## **CALIFORNIA STATE POLYTECHNIC UNIVERSITY, POMONA COMPLETE STREETS SAFETY ASSESSMENT Issues, Opportunities, and Suggested Strategies**

**FINAL REPORT**

**OCTOBER 2022**

### Figure 3-3: Camphor Lane Observations

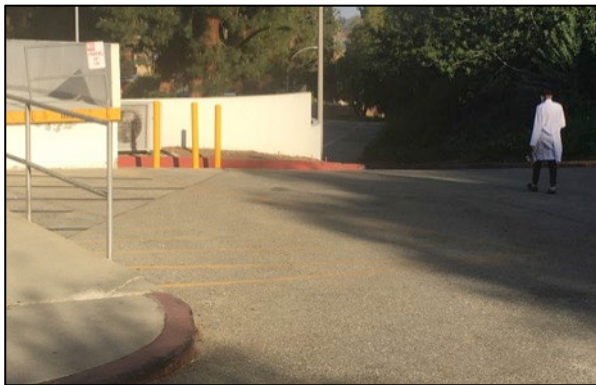
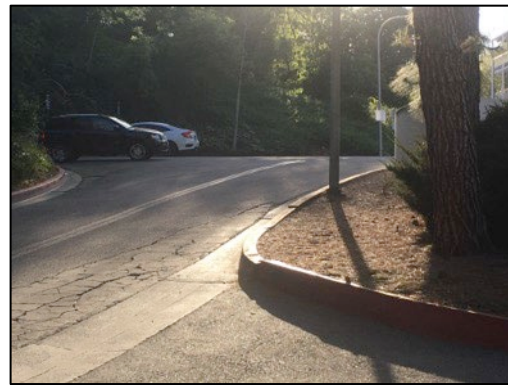
As shown in Figure 3-3 a & b, there is a marked mid-block crosswalk at base of the staircase up to the Kellogg West Conference Center, at the location indicated by a yellow rectangle in Figure 3-2. Single-sided W11-2 (Pedestrian Symbol) signs face each approach. The east-facing sign (on the north sidewalk) is mounted to a streetlight pole. The west-facing sign is mounted on a wooden

post at the base of the stairs, in an area that no pedestrians traverse. Neither is accompanied by a W16-7p Downward Pointing Arrow plaque to indicate the crosswalk location.

#	Location	Item	Suggestion
1	Crosswalk at Kellogg Center staircase	Warning signs	Add W16-7p Downward Pointing Arrow plaques below the existing W11-2 Pedestrian Symbol signs. Ensure that the bottom edge of the north sign assembly is at least 7’ above the sidewalk. (The south sign assembly is in a non-walking area.) Consider adding a west-facing sign assembly on the northern pole (the one on the sidewalk).
		Stair base lip	Remove trip hazard by reconstructing step or conforming asphalt
2	Building 5 loading dock area and retaining wall	Sidewalk gap	Install sidewalk for approximately 50’ along wall, in landscape area. Consider adding two white lines across dock area and lower driveway.
3	Bicycle accommodations	Markings	Consider placing Shared Lane Markings (“sharrows”) at each end and spaced periodically in-between.
		Regulatory signs	Consider R117 (CA) “PASS [BIKES] 3 FT MIN signs just in from University Drive and facing east before the grade behind Building 5.

**Figure 3-4: Camphor Lane behind Building 5 – sidewalk gap closure concept**

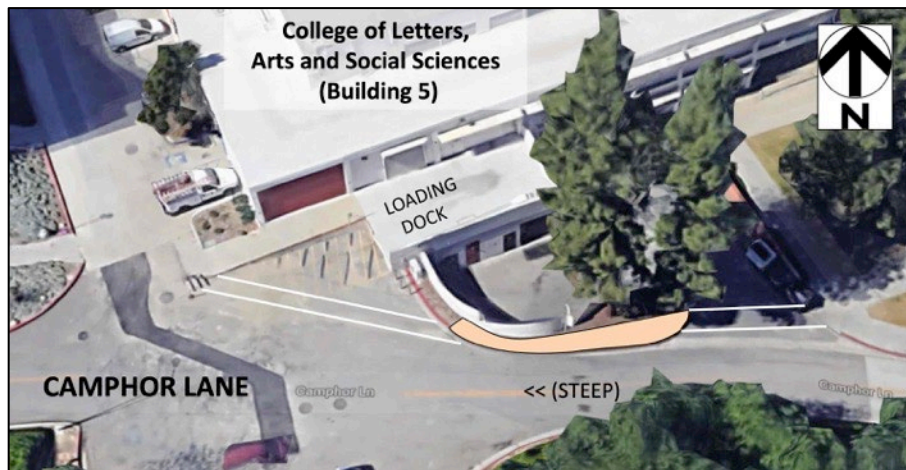
There appears to be sufficient width to install a 36" or wider sidewalk along the side of the existing retaining wall. Striping a walkway (two white lines) diagonally across the loading dock area would guide pedestrians to this added sidewalk segment.

Figure 3-12: Parking Structure 1 south access at Palm / Oak

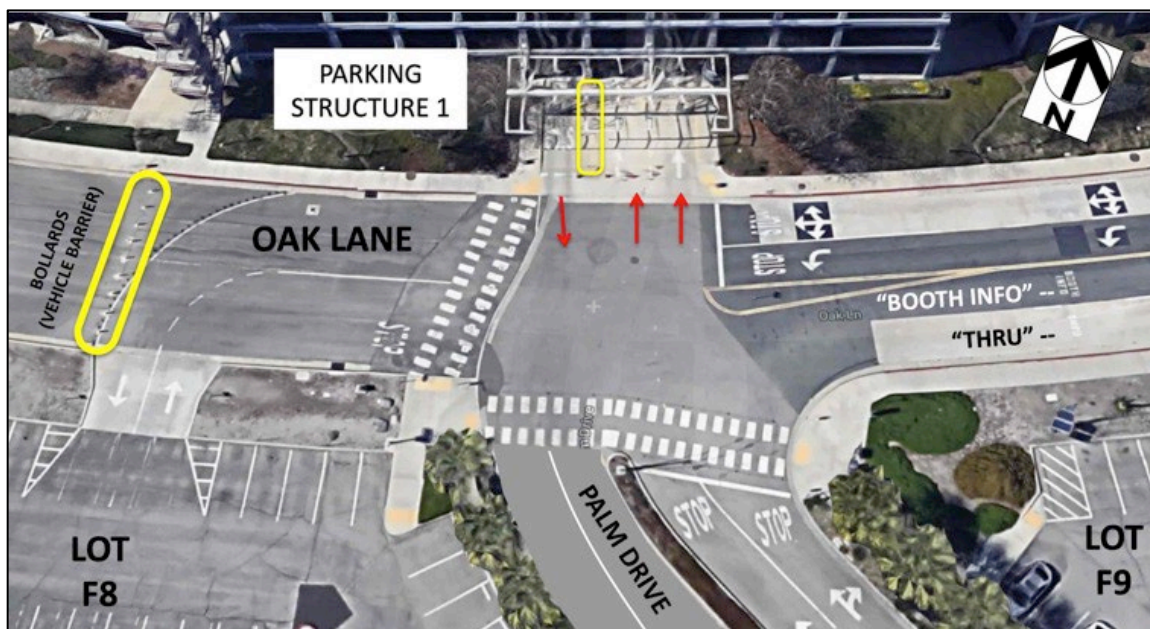
Crosswalks with "Triple-4" patterns are present on the west and south (Palm) legs. The south crosswalk (across Palm) has bollard-triggered In-Pavement Warning Lights (no buttons to press). There are no crosswalk markings across the north (PS1) leg or the east (Oak) leg.

The north crosswalk spans PS1's two entry lanes and single exit lane. Rectangular islands that protect the structure's columns separate these three lanes. Extending those islands to the north sidewalk would provide refuge areas for pedestrians there.

#	Location	Item	Suggestion
1	East leg & crosswalk	Improving for pedestrians	Widen the painted median island to the south to narrow the departure to one lane. Install a raised island. Mark crosswalk.
2	North leg (PS1) crosswalk	Improving for pedestrians	Extend the two islands between the lanes, southward to the back of the north sidewalk, to serve as refuge areas for north-leg pedestrians.
3	Cypress Lane	South dead-end	Consider connecting to westbound Kellogg Drive with a right-turn-out-only junction (i.e., no ingress from Kellogg and no access to eastbound Kellogg).

**Figure 3-15: Kellogg Drive between Eucalyptus Lane and South Campus Drive**

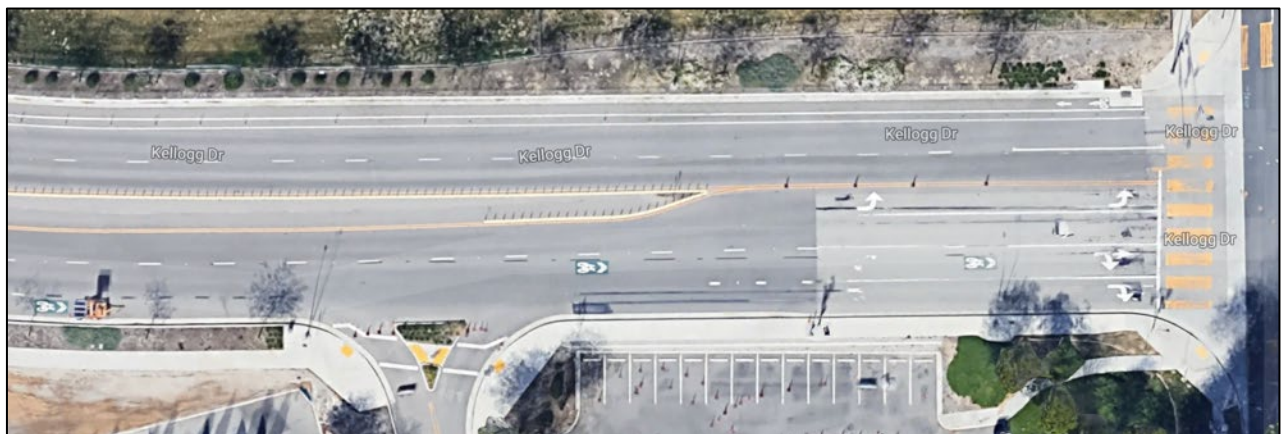
Preparing to proceed through by merging into a shared option lane that carries high traffic volume at peak periods, from which many vehicles turn right, and controlling that lane by riding centered in it, are high-stress maneuvers that can challenge even experienced bicyclists especially in low-light and nighttime conditions. The state of the practice in bikeway network planning uses the Level of Traffic Stress (“LTS”) framework, which rates segments and intersection approaches on a scale of 1 (least stress) to 4 (highest stress). The LTS approach seeks to create a low-stress network that serves all significant destinations with LTS 1 or 2 segments and intersections because higher-stress ones are effectively gaps for traffic-sensitive users. The bicycle movements expected on the southbound approach to South Campus Drive would probably be rated LTS 3 or 4.

b) Separators (both directions)	Short-term: Evaluate options for replacing or augmenting the raised separators with more durable devices that provide equal or superior protection from motor vehicle traffic.
3	Eucalyptus signal	West leg	If a west-side two-way cycle track is implemented to the south, consider adding a “cross-bike” (two-way bicycle crossing) inboard of the west crosswalk
4	Red Gum Lane Eucalyptus	West side 2-way bikeway	Continue the two-way cycle track north along the west side of Red Gum Lane to either: * the east-west sidewalk along the north side of the Student Services Building’s transit loop, or * just beyond the motor vehicle barrier at the Lot C / Lot F8 driveways
5	Eucalyptus east of Kellogg	Bicycle accommodation	Provide a bicycle ramp between the Eucalyptus/Kellogg intersection’s southeast corner sidewalk area and the western dead end of old Eucalyptus Lane. Provide a bicycle through onto the east-end cul-de-sac of the abandoned segment of Eucalyptus. Add a traffic signal camera to detect bicyclists approaching westbound from the east leg of Eucalyptus Lane. (The four major approaches already have traffic detection cameras.)

**Figure 3-17: Kellogg Drive / Red Gum Lane Cycle Track Network Concept**

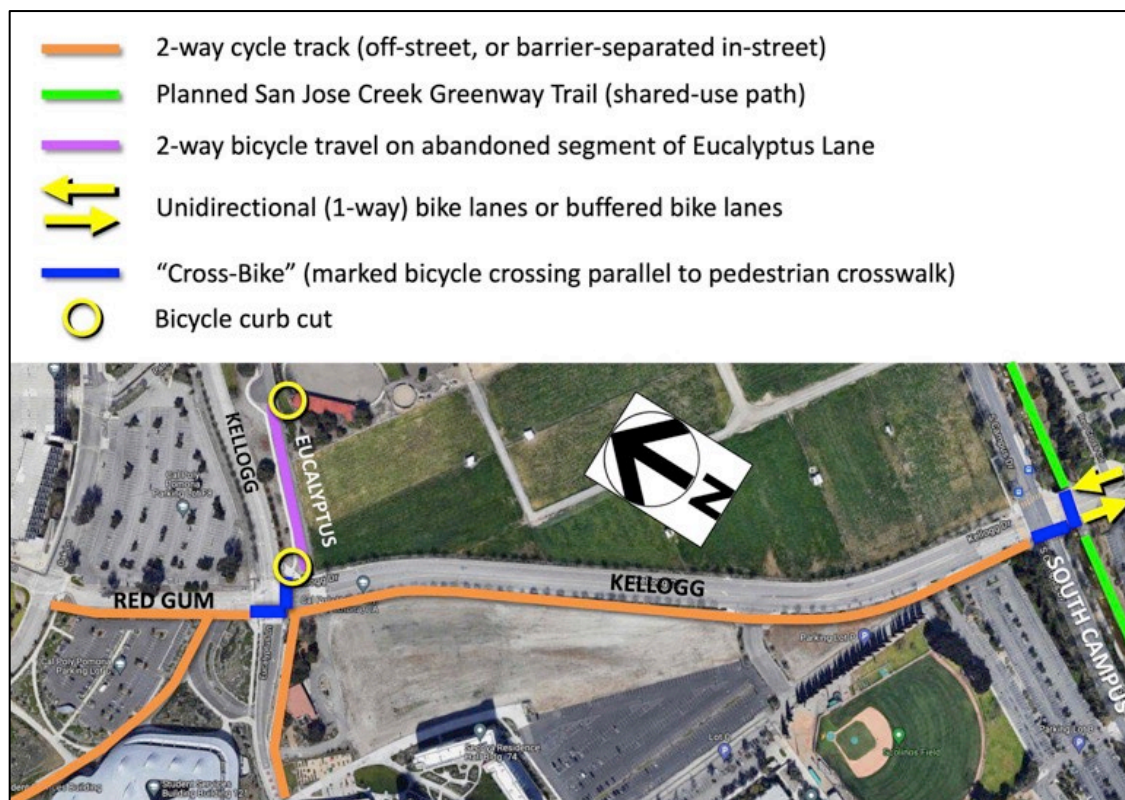
Figure 3-17 illustrates several of these suggestions, with connections to other campus areas.

**Figure 3-19: Temple at University west leg – existing and proposed**

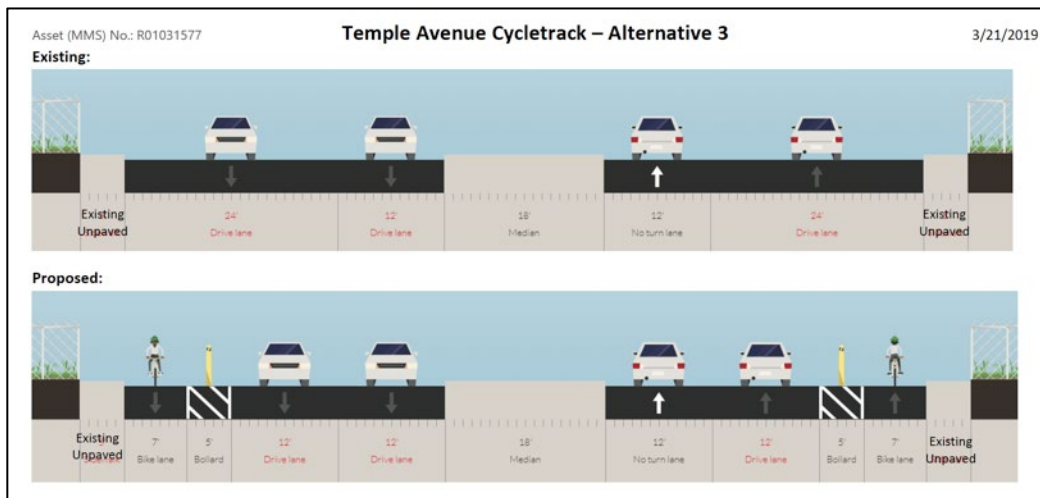
This is a four-way intersection at which bicyclists may legally make all through and turning movements. For commutes to and from campus via the west leg (serving the City of Walnut), the key movements are the left turn from eastbound Temple Avenue and the southbound right turn

onto westbound Temple Avenue. The latter movement will have no conflict with traffic on Temple Avenue because the proposed westbound cycle track will receive it.

#	Location	Item	Suggestion
1	Eastbound approach, south leg	Two-stage bicycle turn box	a) Consider incorporating a turn box near the southeast corner of the intersection, along with appropriate guide and regulatory signs as suggested by Figure 3-21.

Figure 3-23: Temple / South Campus intersection and U-Village route to campus

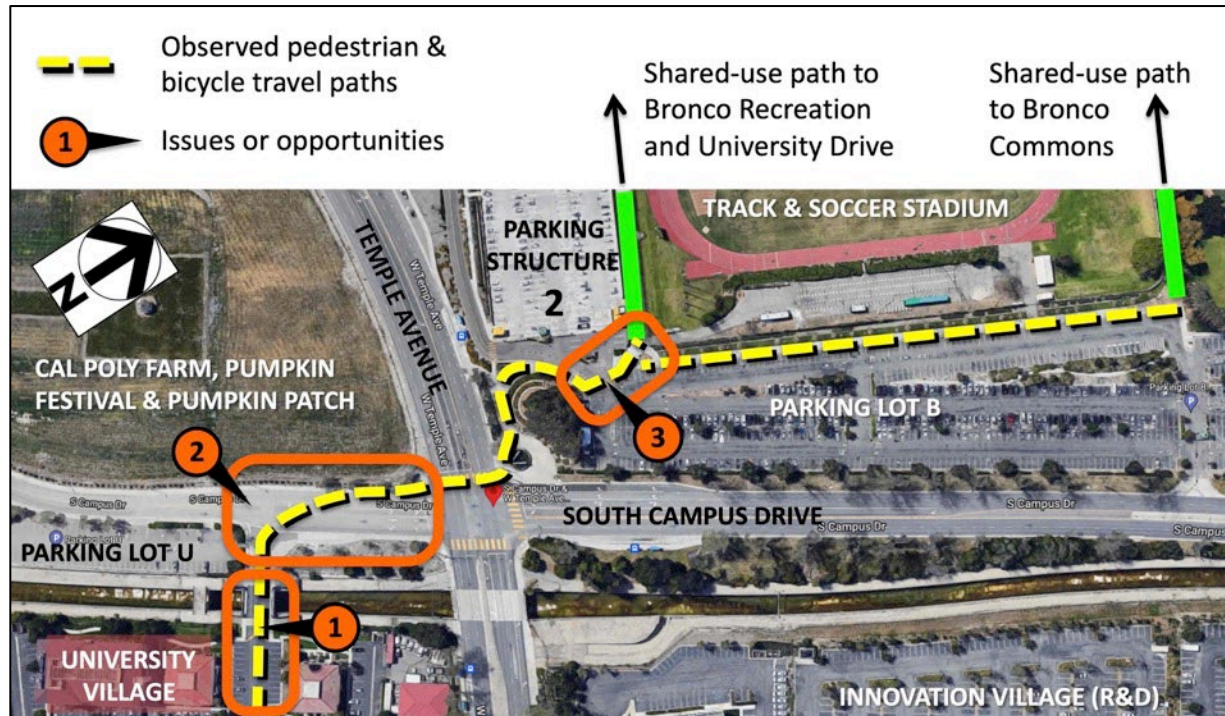
Figure 3-23 shows the intersection and its vicinity, plus two key shared-used paths (green) that connect north through the Athletics complex to Bronco Commons / Recreation, University Drive, and the campus core to the north. The dashed yellow line indicates pedestrian and bicyclist movements observed during the field visit. The numbered orange rectangles indicate areas with opportunities to increase pedestrian and bicyclist convenience, comfort and safety.

As shown by the dashed yellow line in Figure 3-23, most pedestrians traveling from University Village to campus and back do not use the east sidewalk and the intersection's south, east or north crosswalks. They instead walk a direct "desire line" diagonally across South Campus Drive, along the west sidewalk, and cross Temple Avenue at the west crosswalk. From there they follow the wide walkway around the west side of the large monument sign, cross Lot B's northwest access road on a marked crosswalk, and either continue west on the wide path along the north

4	South crosswalk at Temple Avenue	Markings	To provide a higher-contrast edge for guiding low-vision pedestrians across the street, consider adding 12” white or yellow lines adjacent to the existing contrasting pavement treatment.
5	Crosswalks at Temple Avenue	Signal phasing	Consider adding Leading Pedestrian Interval (LPI), a.k.a. Pedestrian Head Start, phasing to the west crosswalk (across Temple) and possibly other crosswalks at this intersection.

**Figure 3-29: University at Kellogg and Eucalyptus – Sidewalk & Crosswalk Concept**

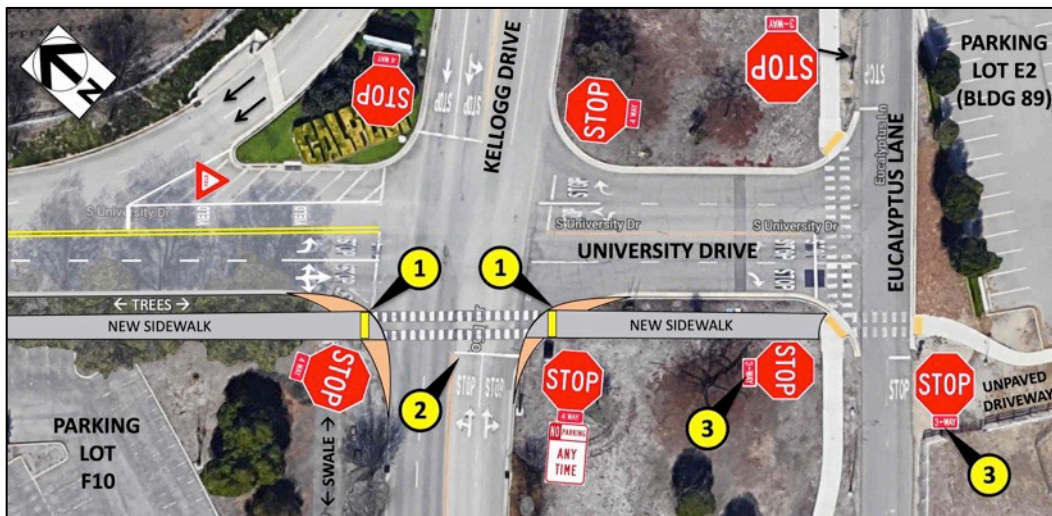
University Drive has no sidewalks or marked crosswalks between Eucalyptus Lane and the main campus. There is ample width to add a sidewalk in the south-side landscape area between Kellogg and Eucalyptus (embanked up, with a few small trees) and west of Kellogg (a line of tall mature trees). The only obstacle is the drainage swale along Kellogg's west side, which can be easily bridged.

The southwest and southeast corner radii seem overly large (approximately 35'). If they could be reduced to, say, 25' that would substantially shorten the crosswalk and also enable the northbound limit line to be moved closer to University. See items (1) and (2) in Figure 3-29.

W11-2 Pedestrian Symbol signs are mounted beneath the STOP signs on University's eastbound approach to Eucalyptus and on Eucalyptus' northbound approach to University. Crosswalk warning signs are not appropriate on STOP- or signal-controlled approaches, so these signs and can be removed (and reused elsewhere). See items (3) in Figure 3-29.

The suggested curb ramps and their detectable warning strips (yellow) are oriented directly across the street because there is currently no need for crosswalks on the west or east legs.

Figure 3-30: Kellogg Drive at Innovation Way – Roundabout Signs And Markings

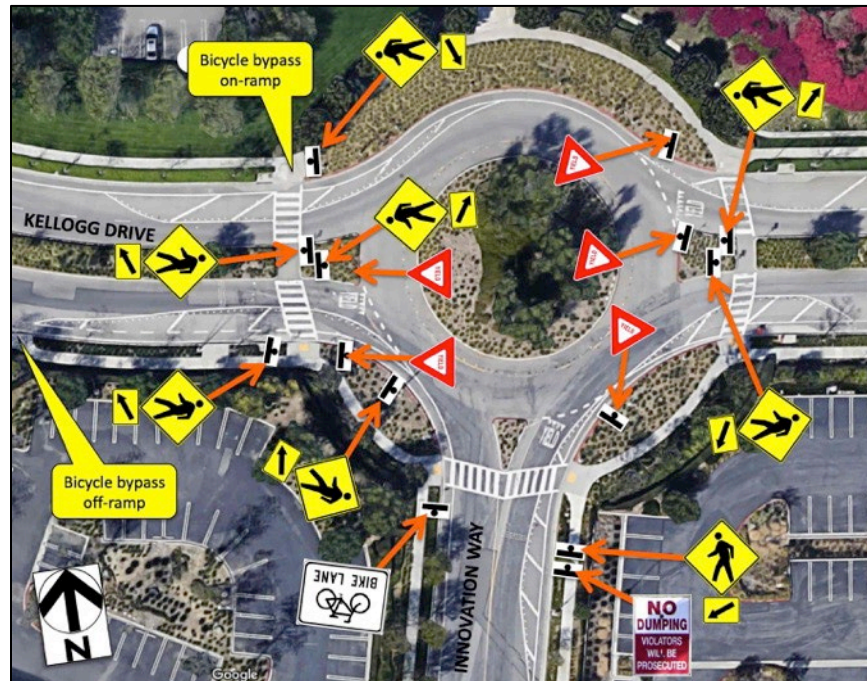
#	Location	Item	Suggestion
1	Circulatory roadway	Large half-round markers	The large half-round markers that define the inner (truck apron) and outer (shoulder) edges are hazardous to motorcyclists, scooter operators and bicyclists, and should be replaced with safe alternatives. [HIGH PRIORITY]
2		Unused sign post	There is an unused sign post by the north curb, midway between the east and west legs. Remove it.
3	South leg (Innovation Way)	Crosswalk	The outer splitter island is only paint, which does not protect crossing pedestrians. Install a raised island.
4		Crosswalk warning sign assemblies	The right-side assembly is not at the crosswalk. Relocate it.
5			Install left-side assembly on new raised splitter island, preferably with its "walker" walking rightward.
6		Bicycle bypass	Install a bicycle bypass ramp to give approaching bicyclists the option to use the sidewalk.
7			In advance of the bicycle bypass, install a guide sign informing left turning bicyclists to either merge (to circulate with vehicle traffic) or use the bypass and the sidewalks.

8		Bike lane line beyond crosswalk	A bike lane line is striped around the northeast corner to guide right-turning bicyclists. It is too close to the gutter for comfortable riding (42" to face of curb). 48" is the minimum standard asphalt-plus-gutter width for a bike lane. Remove and replace (48" - 16" gutter = 32" of rideable asphalt).
9		Yield sign	There is no Yield (R1-2) sign on the splitter island. Install one.
10		Non-standard speed limit sign	Downstream of the departure there is a non-standard yellow 25 MPH speed limit sign. Remove it or replace it with a standard regulatory (black on white) speed limit sign
11		Crosswalk warning sign assembly	The midblock crosswalk south of the roundabout (not the splitter island crosswalk) has no W16-7p Downward Arrow plaque below the W11-2 Pedestrian Symbol sign. Add one.
12		Crosswalk warning sign	The existing right-side sign assembly facing traffic exiting the roundabout onto Innovation Way is mounted to the streetlight pole, which is not at the crosswalk. Relocate this sign assembly to a new sign post at the crosswalk.

#	Location	Item	Suggestion
14	East leg (Kellogg)	Crosswalk warning sign	Add a crosswalk warning sign assembly facing traffic approaching the roundabout.
15		Crosswalk markings	Refresh faded markings
16		Detectable warning	Currently there is no detectable warning strip on the north ramp of the crosswalk. Install one.
17		Right-side Yield (R1-2) sign	The right-side Yield sign on the approach does not appear to face approaching traffic. Rotate the sign to address this.
18	West leg (Kellogg)	Street name signs	The existing street name signs around the intersection are too small to be legible at approach speeds and distances. Consider adding larger low-mounted street name signs on the all splitter islands just before the crosswalks, facing inbound traffic.
19		Crosswalk warning sign	The existing right-side sign assembly facing westbound exiting traffic is not at the crosswalk, as it should be (the downward arrow should point at the crosswalk). Relocate this sign assembly to the crosswalk.

**Figure 3-34: Signs And Markings – Issues And Opportunities**

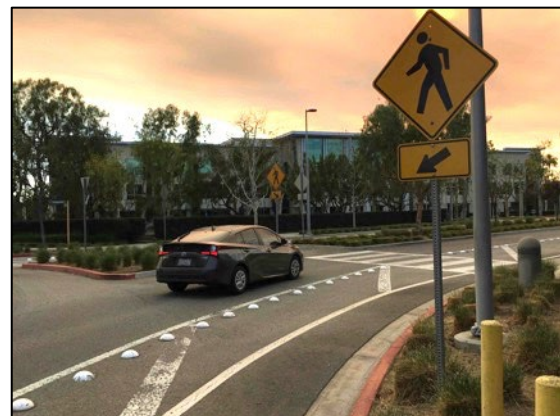
a) Eastbound approach – merge decision point.  
Left-side “walker” symbol should preferably walk *toward* the approach conflict.

b) NB approach -- merge / bike lane / bypass  
decision point (no bypass off-ramp)

c) Street name signs distract from Yield and from  
warning signs (which is upstream of its crosswalk)
